The Hong Kong Council of Social Service
Tender Invitation – Supply and Install window-type air conditioner at Yip Shing
Street Modular Social Housing Project

Tender Addendum

<u>RFP Ref. No:</u>	SH/2022/002
<u>Invitation for tender:</u>	Request for Proposal on Supply and install window-type air conditioner at Yip Shing Street Modular Social Housing Project
<u>Date of Invitation to Tender:</u>	15 August 2022
<u>Closing Date & Time:</u>	30 August 2022 (Tuesday) 5pm
<u>Proposal submission address:</u>	The Hong Kong Council of Social Service (HKCSS) <u>The Tender Box</u> , 13/F, Duke of Windsor Social Service Building, 15 Hennessy Road, Wan Chai, Hong Kong

Figure 1

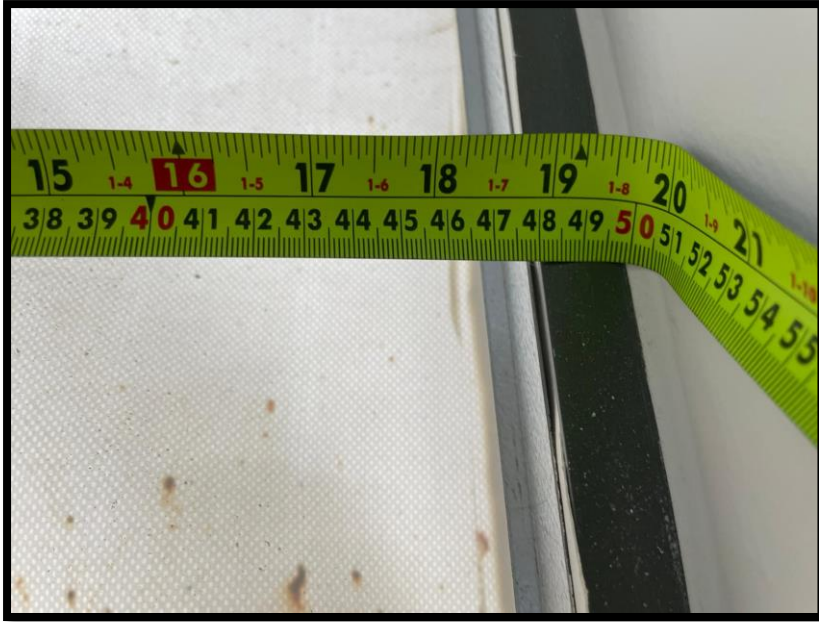
1. The size of air conditioner installation: (Please refer to Figure 1&2)
363mm (H) x 480mm (W) x 640mm (D)

Figure 4

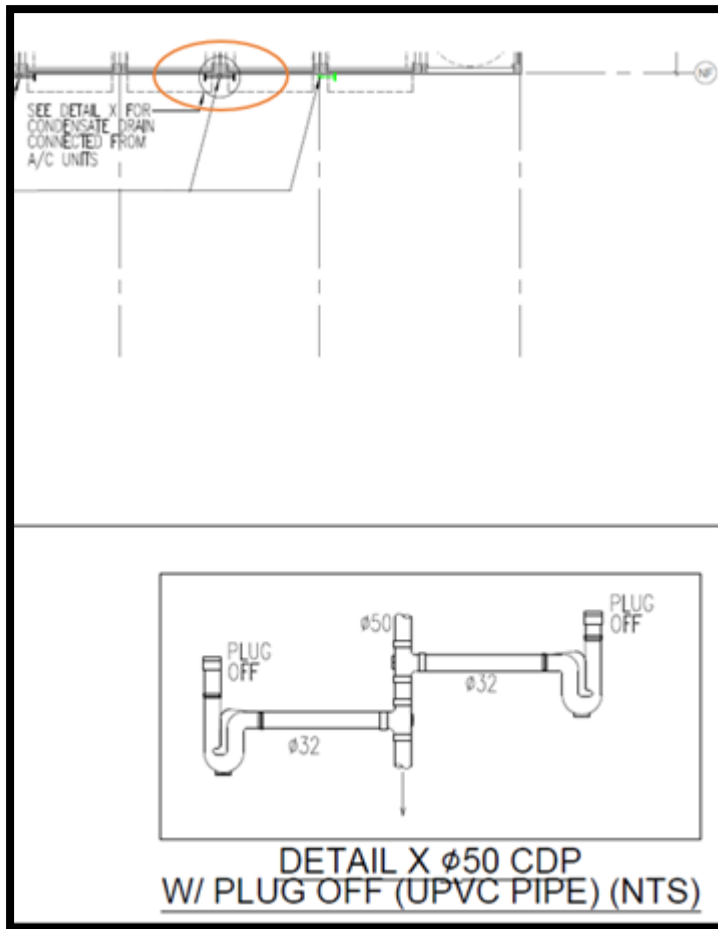
4. Condensate water shall be connected to condensate drain pipe at external wall.
(Please refer to Figure 4)
